# Access Compliance Report

## Public Rights-of-Way

| Intersection ID: 5243 | Main Street: CHIDLEY_DR | Cross Street: HUBBARD_RD | Location: NE           |
| ADA ID: A548A4D419BC  | Ramp Type: Perp         | Initial Pass/Fail: Fail  | Overall Compliance: No |

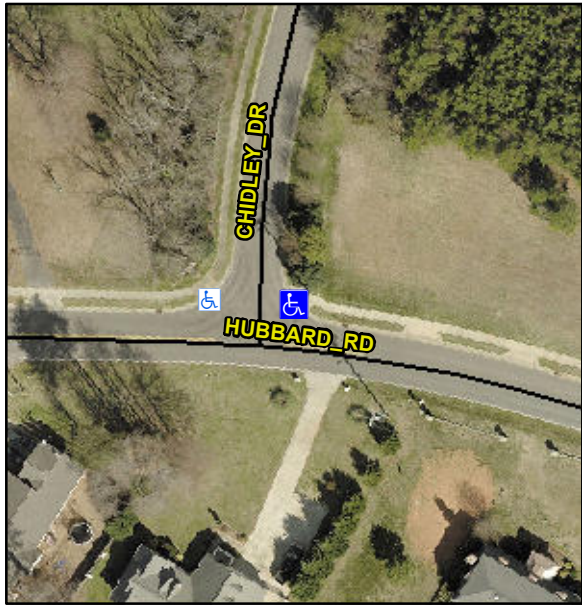
| Codes/Mitigation Info/Possible Solution  |                               |     | Field Measurements/Component Compliance |                       |      |                             |                       |      |
|--|-------------------------------|-----|---|-----------------------|------|-----------------------------|-----------------------|------|
|  | Remove & Replace Entire Ramp. |     | N/A                                     | Ramp Length (in)      | 48.0 | No                          | Ramp Slope (%)        | 10.5 |
|  |                               |     | Yes                                     | Ramp Width (in)       | 48.0 | No                          | Ramp XSlope (%)       | 2.2  |
|  | Not Found, R304.2.2, R304.5.3 |     | N/A                                     | Gutter Lip Ht (in)    | N/A  | N/A                         | Gutter X Slope (%)    | N/A  |
